# Elizabeth Drive East Upgrade

## Submissions Report

October 2024

Figure 5-6: Recorded threatened species – Sheet 6 of 6

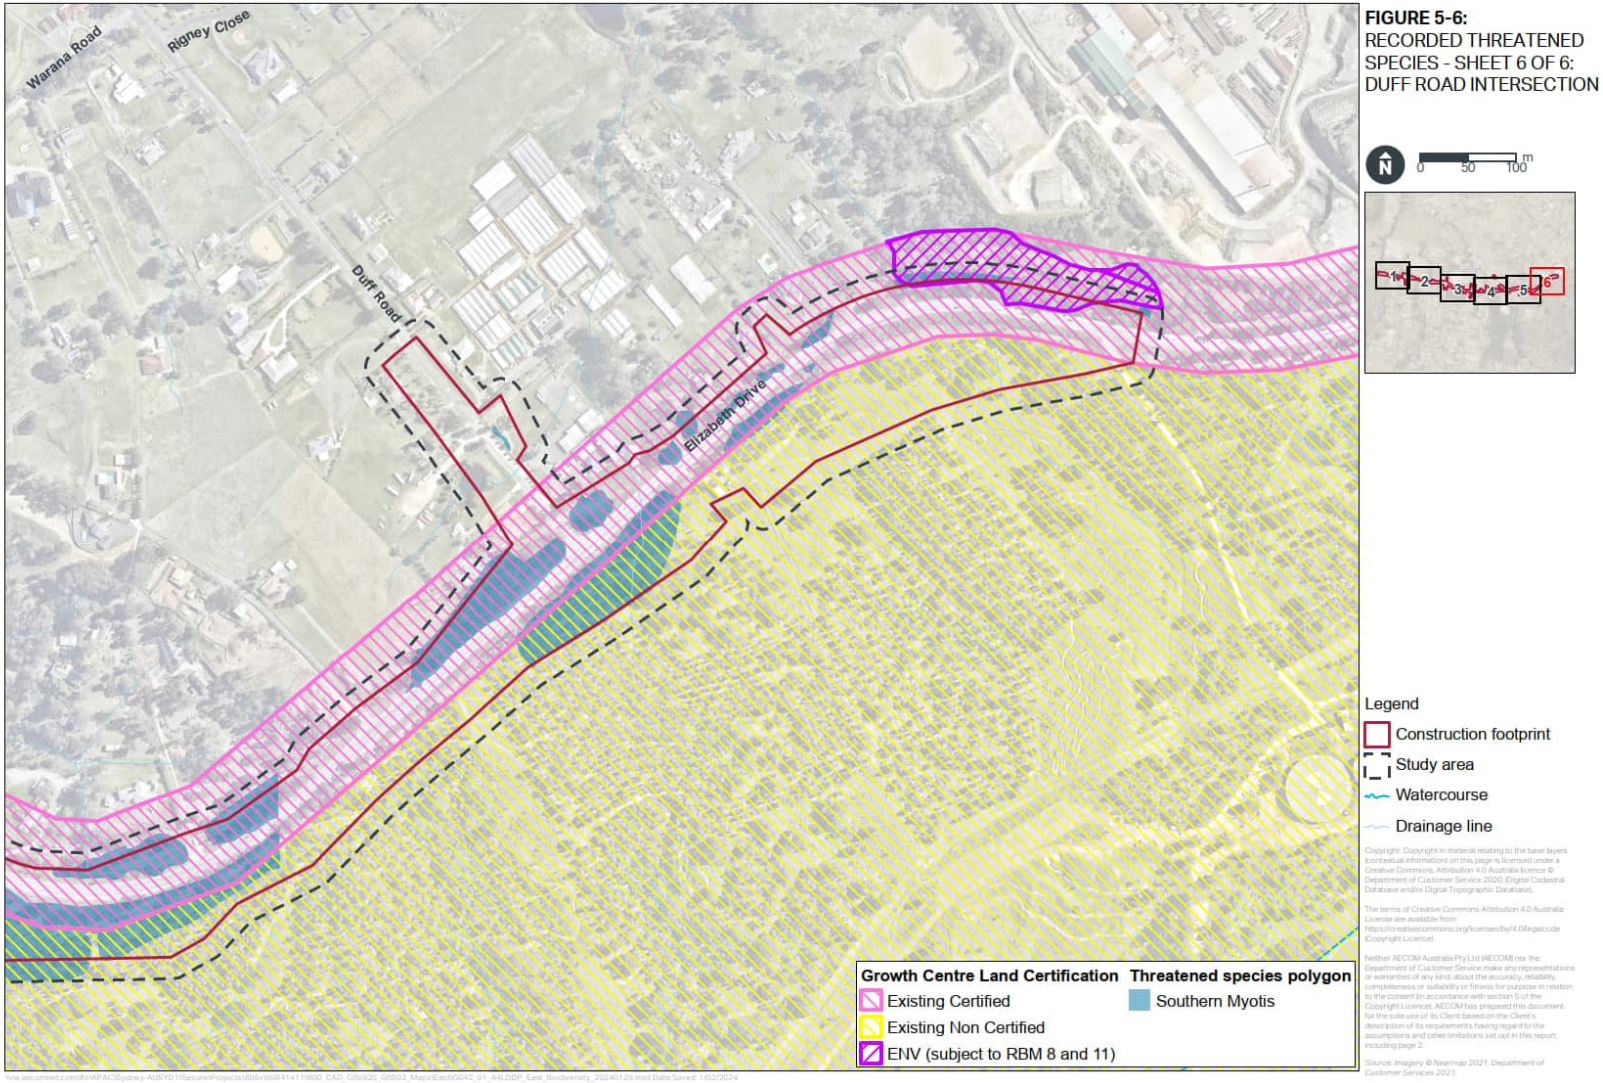
Council noted that threatened species maps were not included. Figure 3-4 only includes a single map which shows the species polygon for *Acacia bynoeana* and maps for all other threatened species have not been included. Council advised that this missing information adds to the difficulty of understanding the potential distribution and impacts to threatened species.

The revised BAR (Appendix B) includes an updated version of Figure 3-4 which presents the location of recorded threatened species during targeted surveys carried out in October and November 2023. This includes the following species:

A summary of the threatened species considered to have a ‘moderate’ or ‘higher’ likelihood of occurring within the study area following targeted surveys carried out in October and November 2023 is provided in Table 5-2. These species were recorded during the surveys. The recorded threatened species are also shown in Figure 5-1 to Figure 5-6.
